NOTICE OF DECISION 400 E Quail Drive – Accessory Dwelling Unit Design Review – DR122-0007

Re: DR122-0007 – 400 E Quail Drive – ADU – Notice of Decision

400 Quail Drive – Accessory Dwelling Unit Design Review – DR122-0007

Site Plan

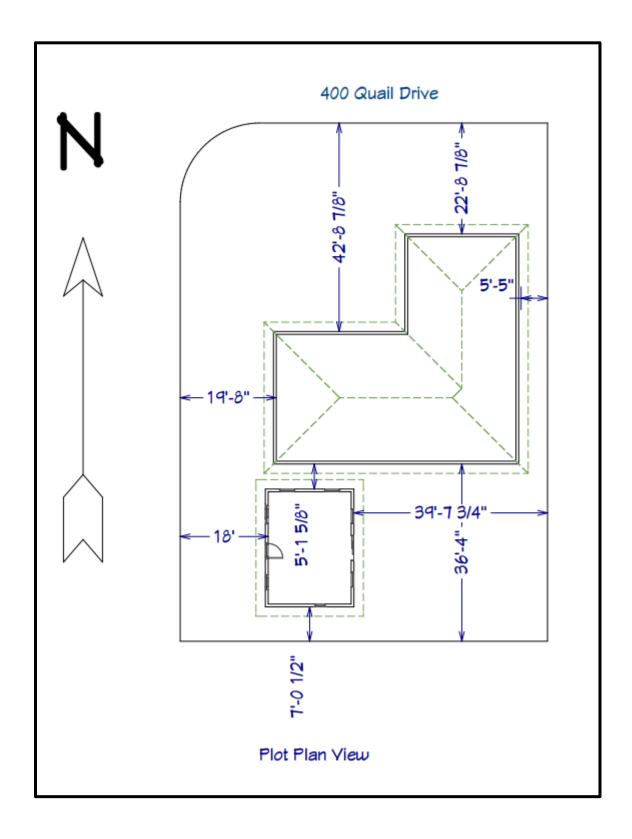
Finding: According to the applicant's site plan, the proposed ADU will be set back at least 7 feet from the south property line, and 39 feet and 7 inches from the east property line, both interior property lines. The north and west property lines are street frontage property lines that were previously addressed. No alterations will be made to the existing dwellings setback requirements. This criterion is met.

A-2

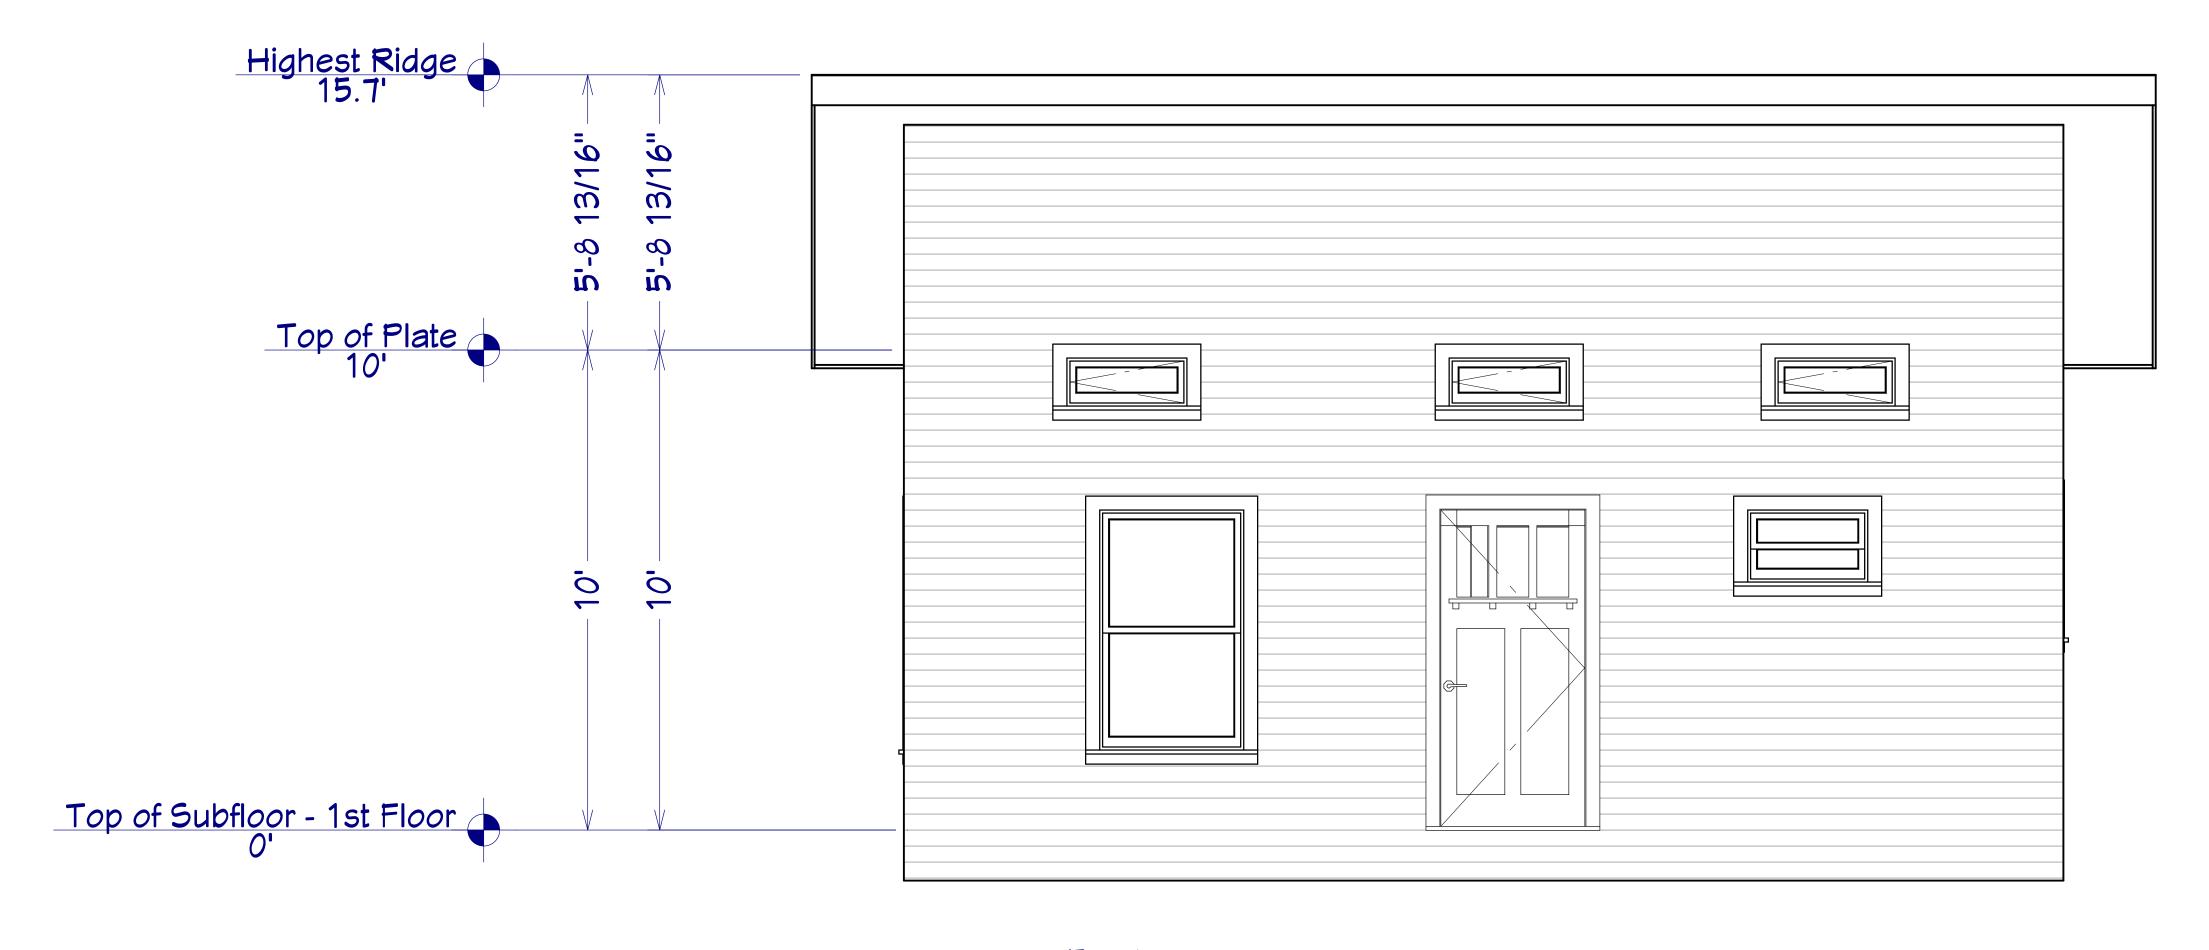
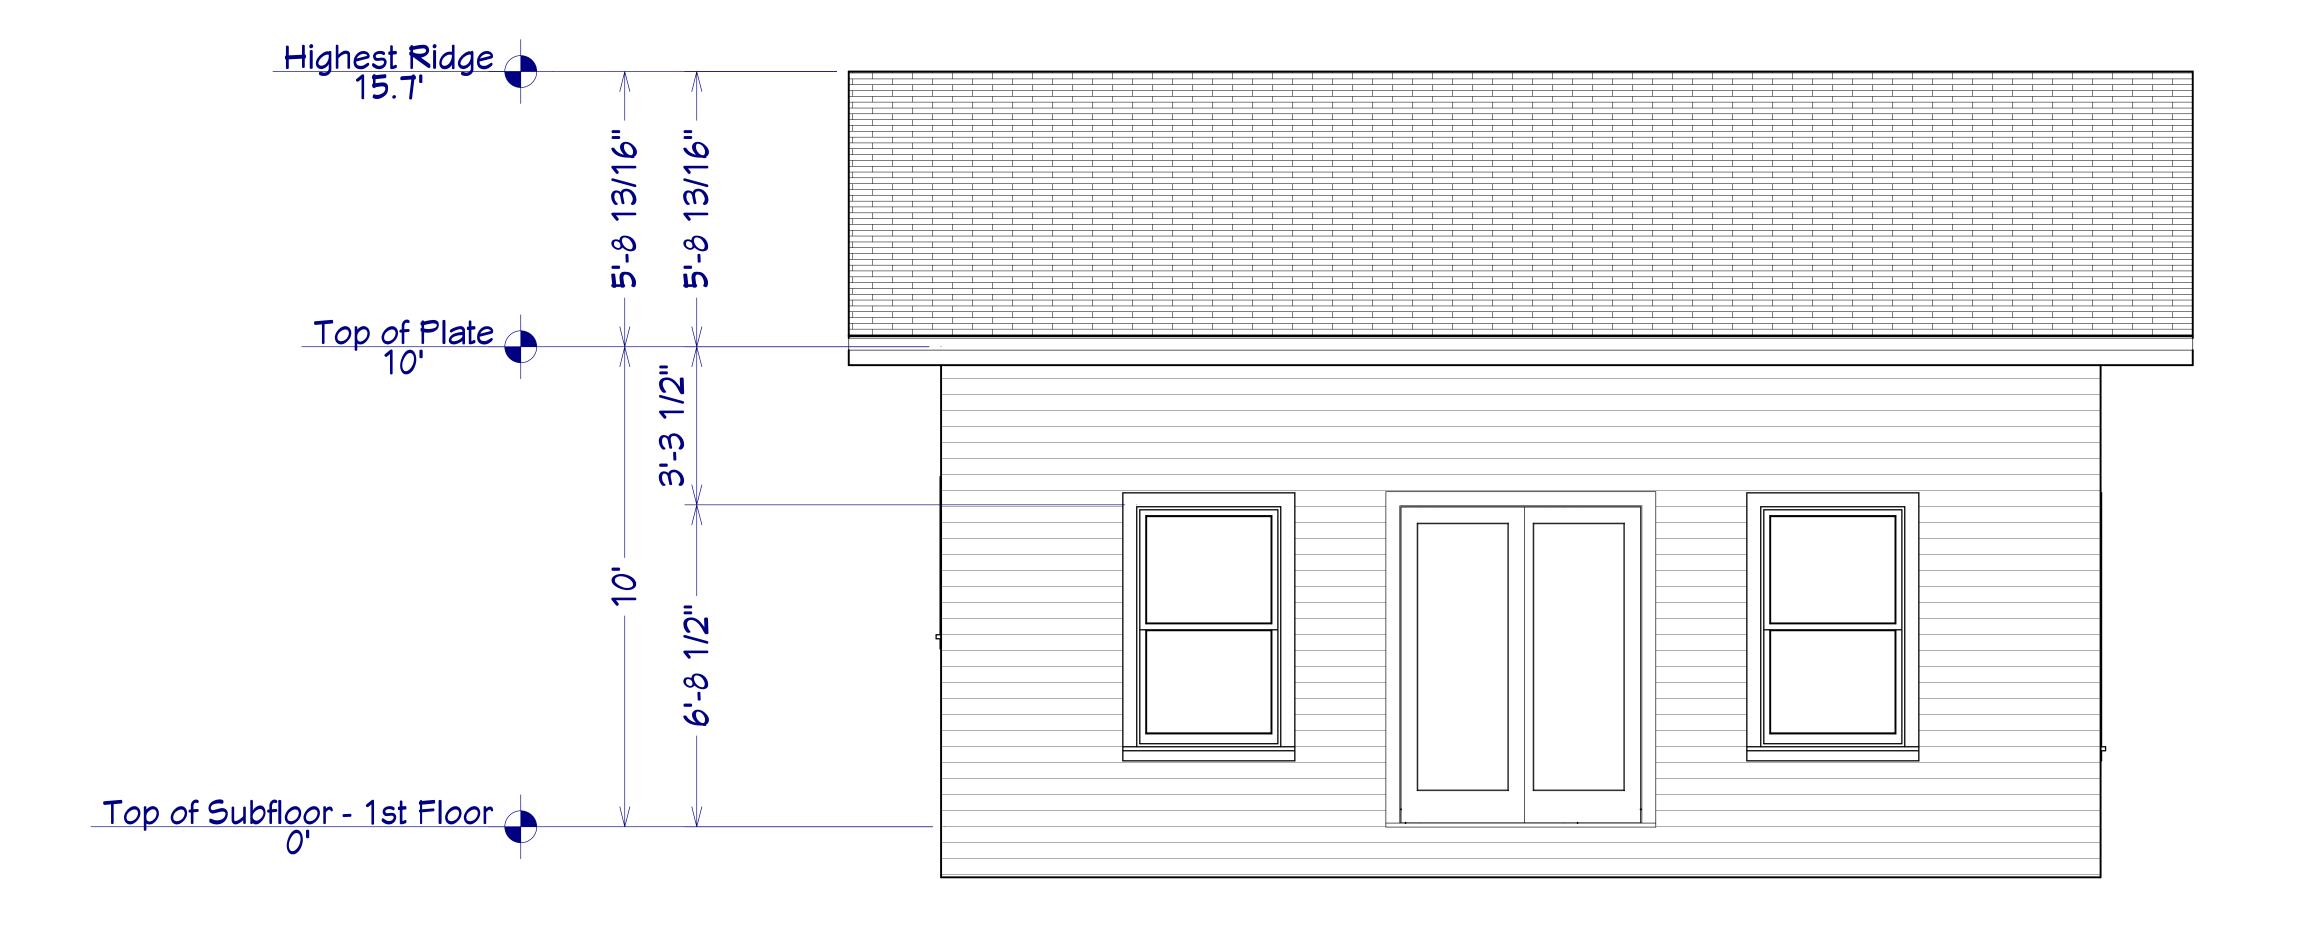
Finding: Per the provided elevation drawings and narrative the maximum height of the ADU will be 15-feet and 7-inches. This criterion is met.
